KENWOOD

SERVICE BULLETIN AMATEUR RADIO

SUBJECT		DATE
TM-531A 20MHZ	OFFSET MODIFICATION	12/27/89

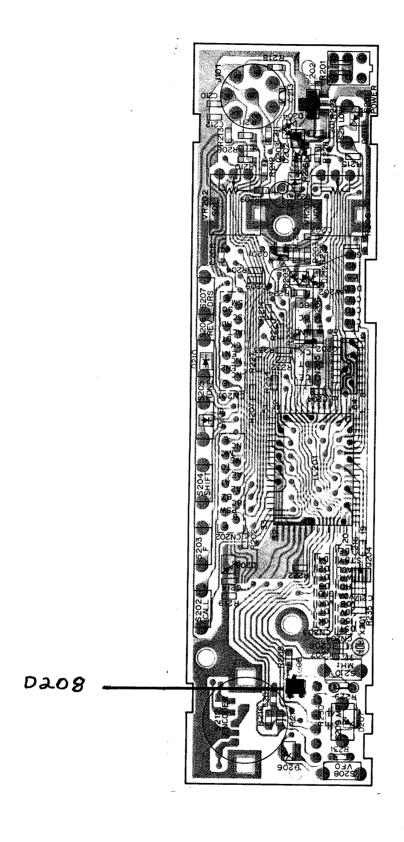
The TM-531A offset can be changed from 12MHz to 20MHz by performing the following modification. It is recommended that this modification be performed at the dealer level since they have the correct tools to disassemble the transceiver.

- Disconnect the power supply and antenna.
- 2. Remove the top and bottom covers (2 screws on each cover).
- 3. Pull the 3 knobs off the front panel.
- 4. Remove the nut from the microphone jack.
- 5. Remove the nut from the rotary encoder.
- 6. Remove the 4 screws from the front panel assembly (1 on each side, 1 on the top, and 1 on the bottom).
- 7. Pull the front panel off the body of the transceiver.
- 8. Remove the 3 screws from the TX-RX board (X57-3340-11 B/2).
- 9. Pull the board off the body of the transceiver, but do not disconnect the wire harness.
- 10. Locate D208 on the foil side of the TX-RX board (FIGURE 1).
- 11. Desolder and remove the diode.
- 12. Assemble the transceiver by reversing steps 1 9.
